Project Name: Pearl Fire Stations

Project Number: 22-099 & 22-108

ADDENDUM NO. 03

1 FOUNDATION PLAN
1/8" = 1'-0"

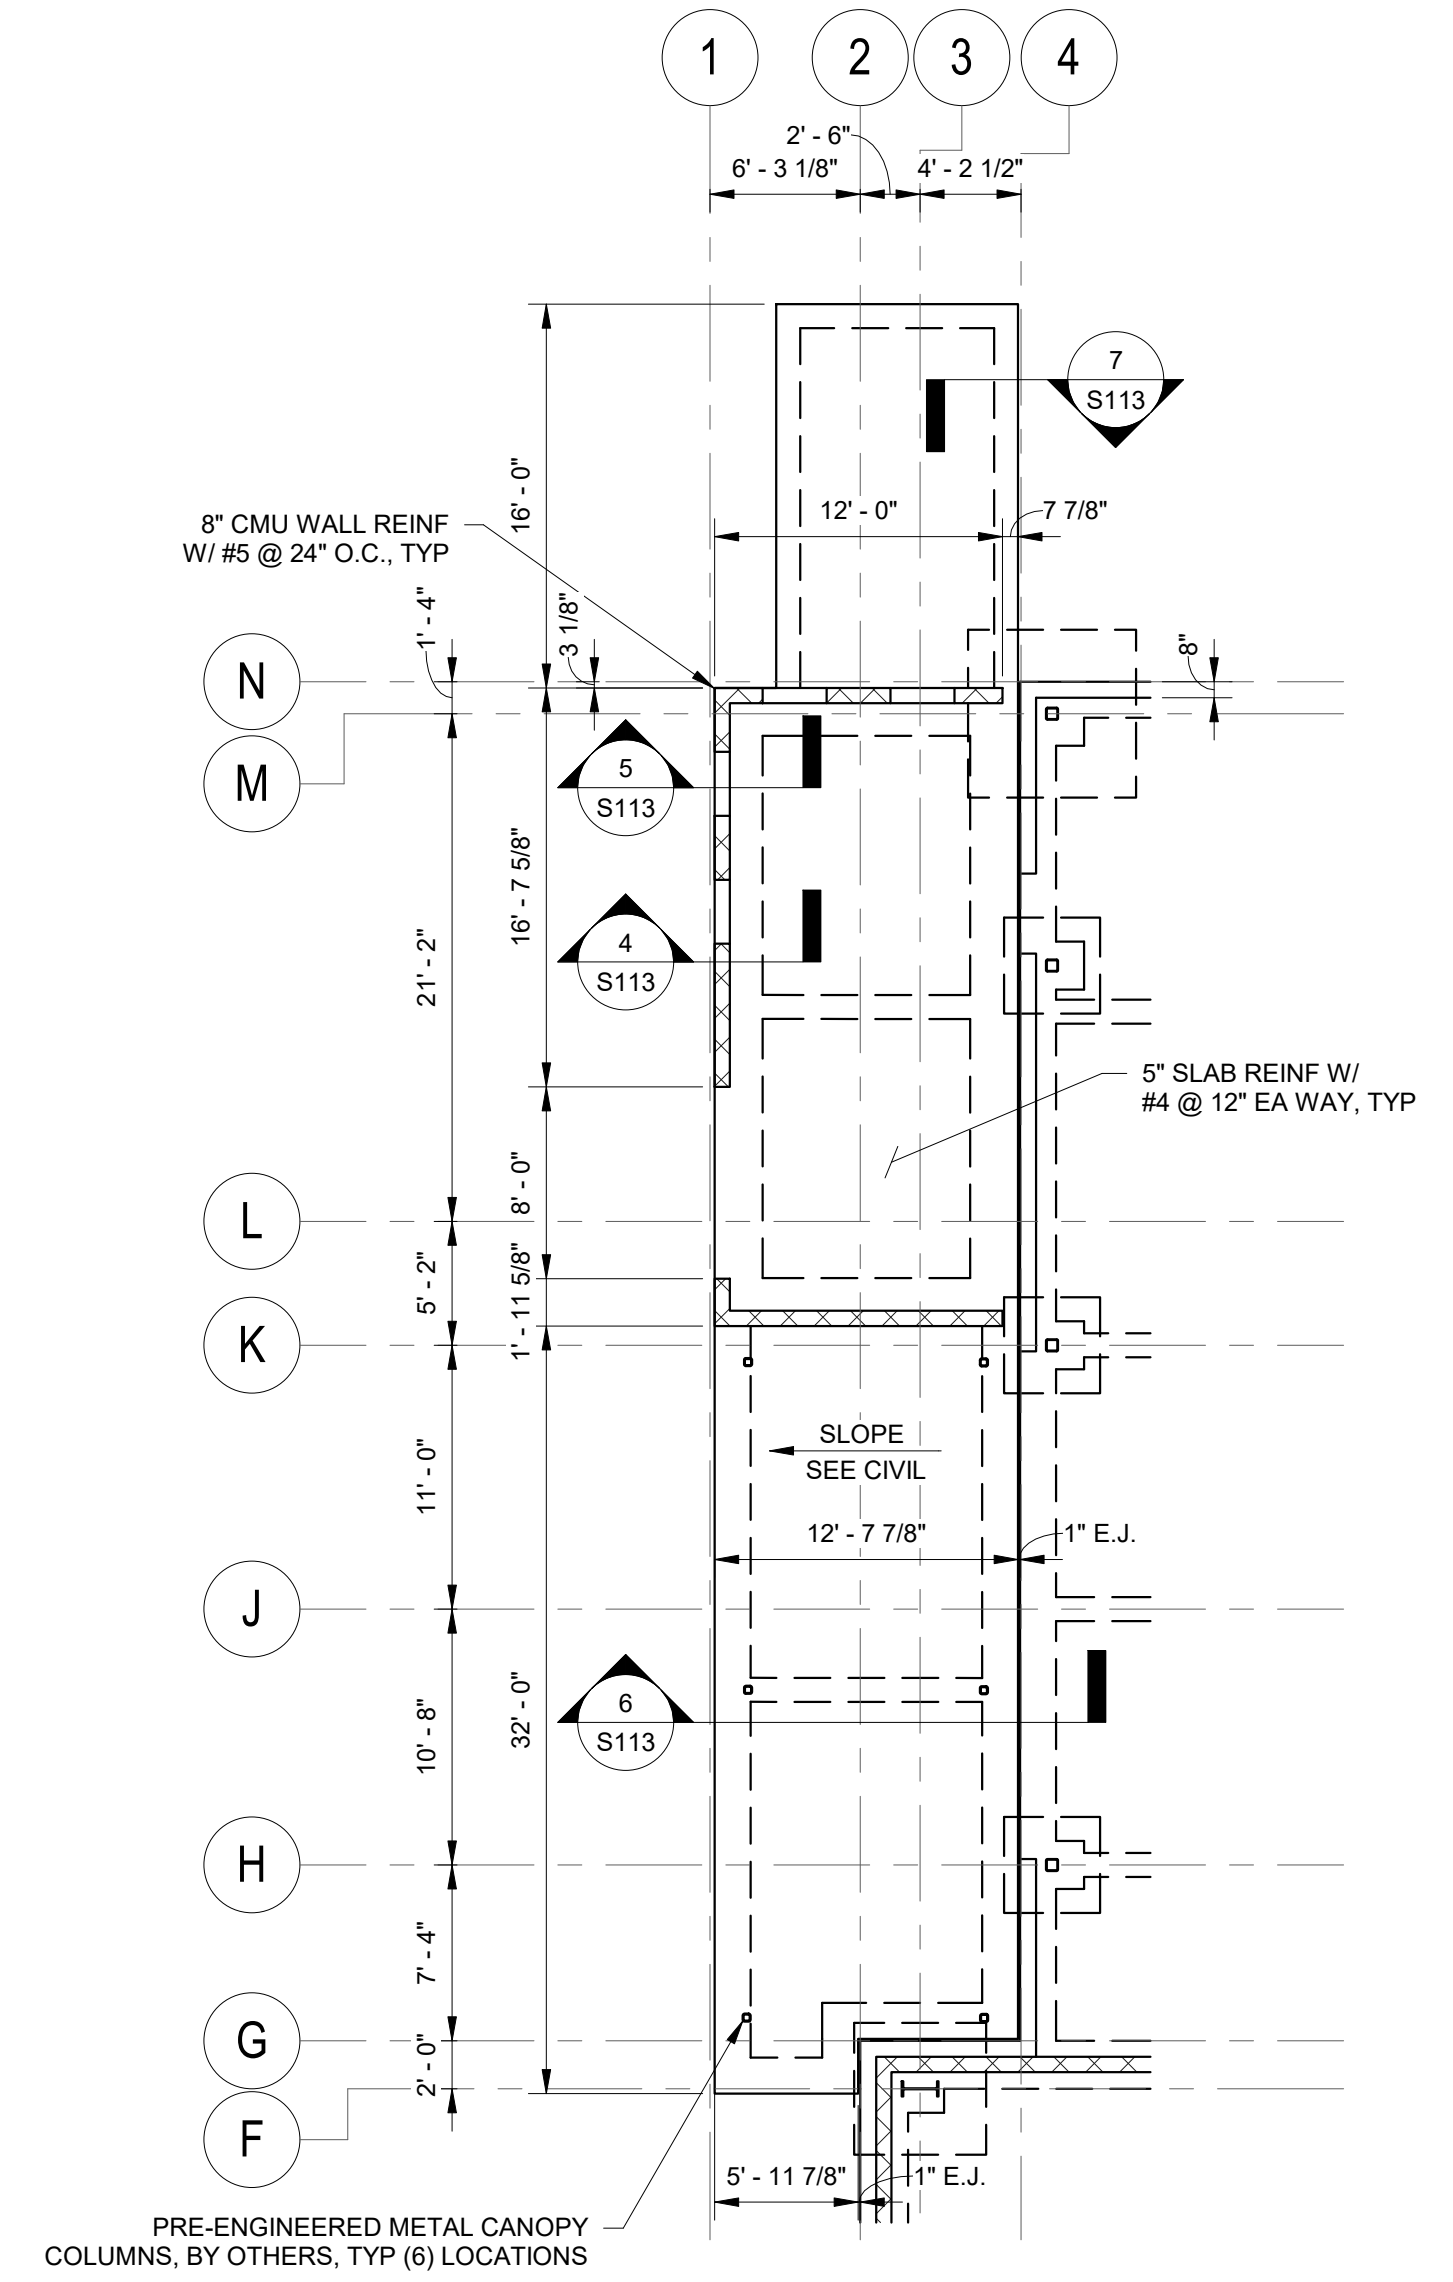
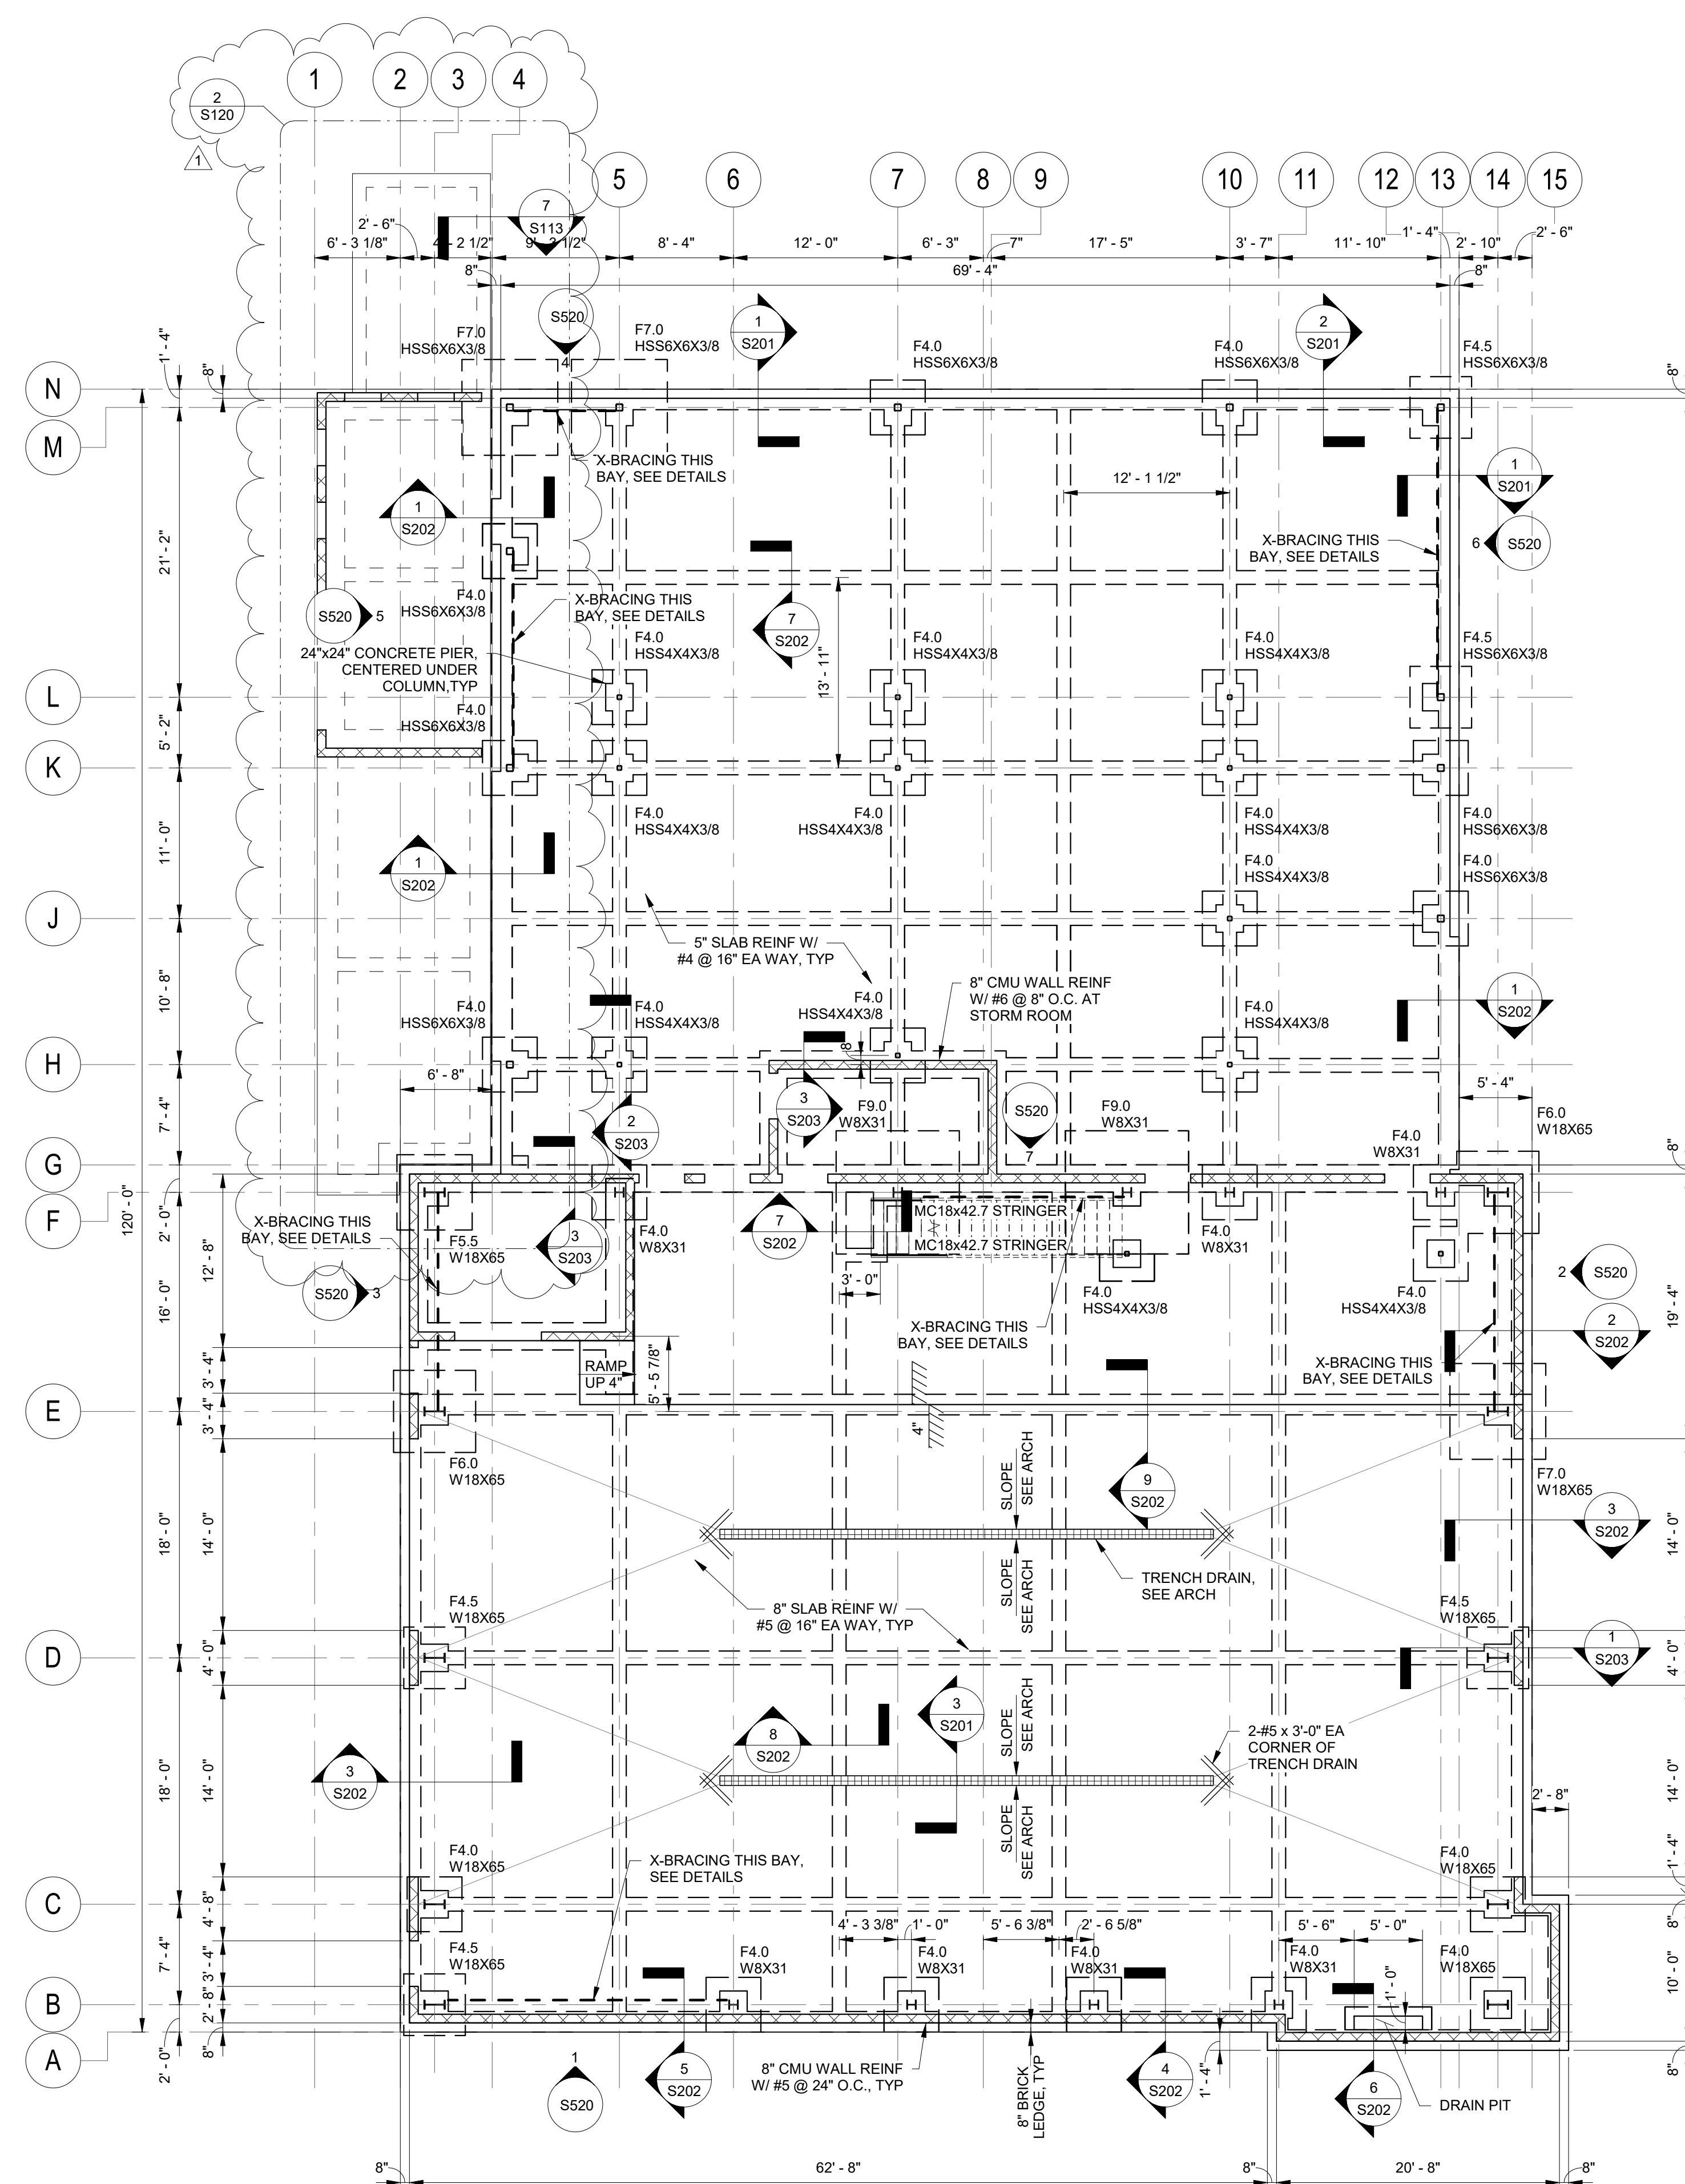
- ITEM NO. 12 **S120 Foundation Plan - Station 5**
REPLACE Sheet S120 with the attached **Revised Sheet S120**.
Clarification: Sheet revisions include foundation/slab information for patio slab, mechanical enclosure, and generator pad.

1 POWER PLAN - FIRST FLOOR
 E210 Scale: 1/8" = 1'-0"

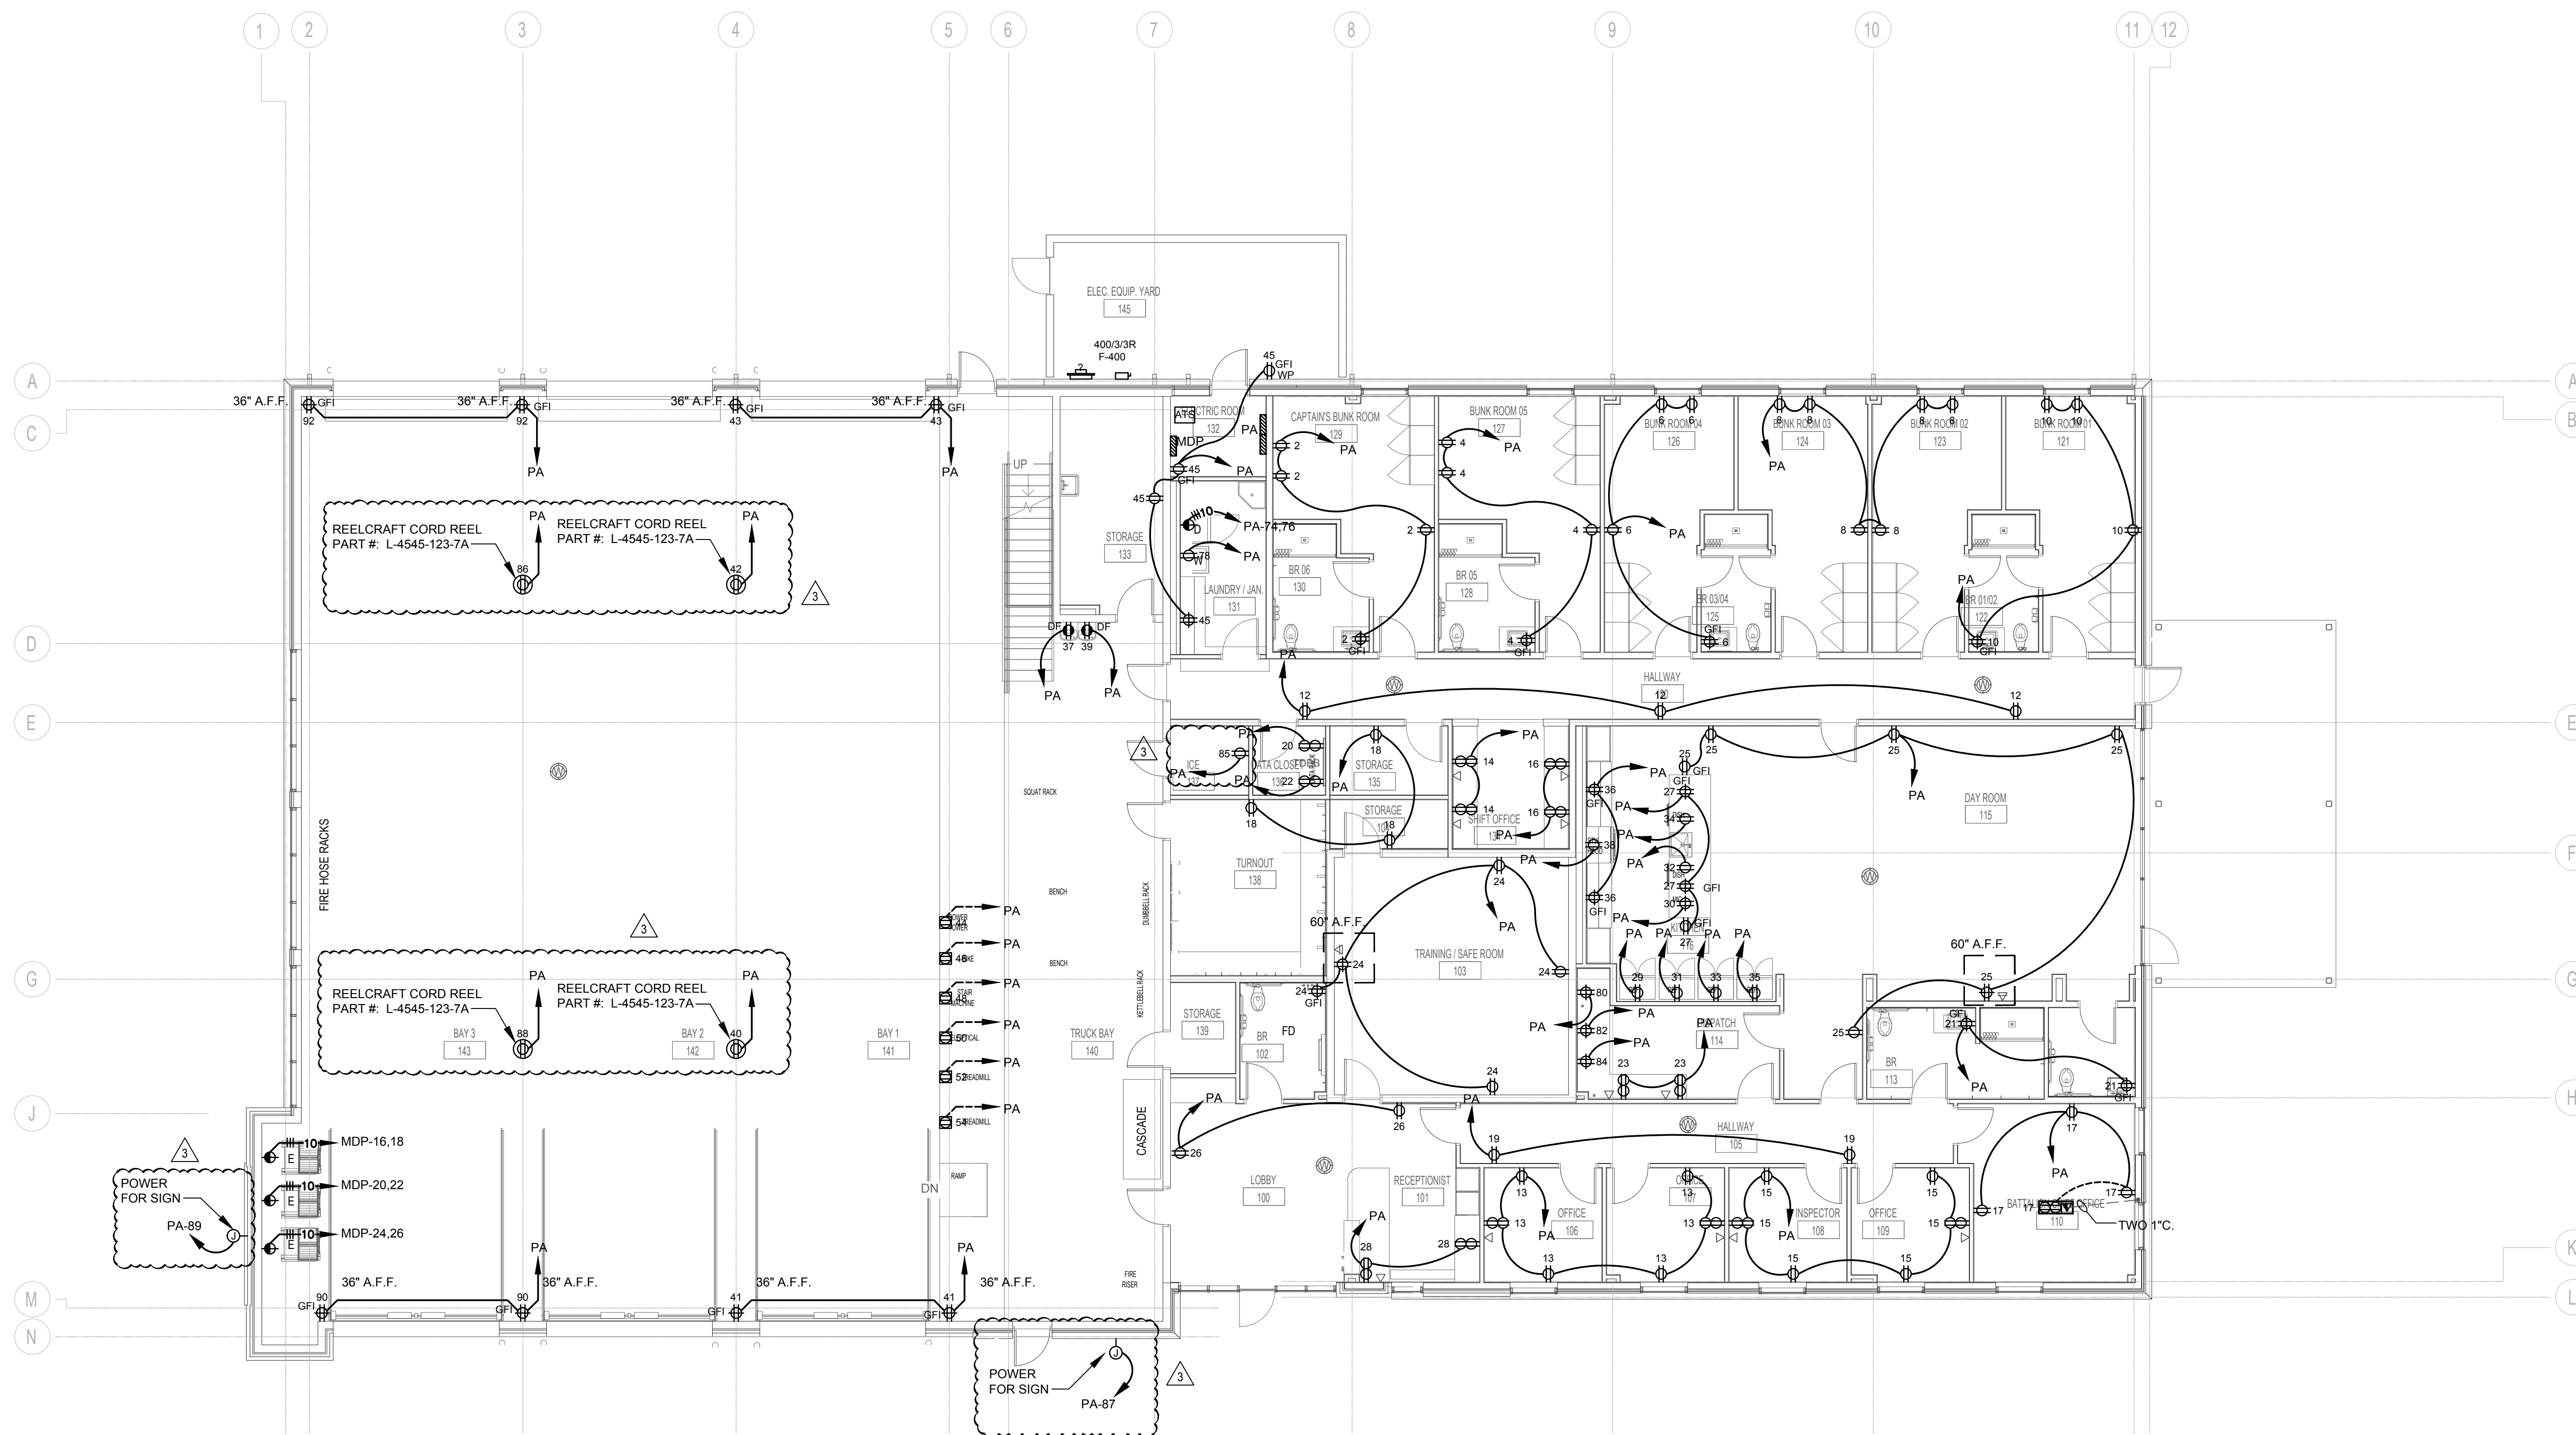
27	Assume Fire Hose Racks and all Exercise equipment including benches and mirror are N.I.C.?	7-Sep-23	Alvin Willey, Thrash Commercial Contractors, Inc.	Correct.
28	E210 & E220 show Cord Reels, Please advise if we are to provide them. If we are to furnish them, please provide more detail for what is needed.	7-Sep-23	Alvin Willey, Thrash Commercial Contractors, Inc.	See revised electrical drawings, issued via Addendum 3
29	E210 shows a symbol not shown on the electrical legend, are we to assume this is a floor box? Please provide more detail for what type is to be used.	7-Sep-23	Alvin Willey, Thrash Commercial Contractors, Inc.	See revised electrical drawings, issued via Addendum 3
30	Please verify if the following is acceptable for the plastic laminate faced cabinets. Can the cabinets bodies / semi-exposed surfaces be white melamine with a particleboard core with plastic laminate on the exposed surfaces and the doors & drawer front be plastic laminate on a particleboard core.	8-Sep-23	Sherman Dukes, Scanlon-Taylor Millwork	Provide as detailed.
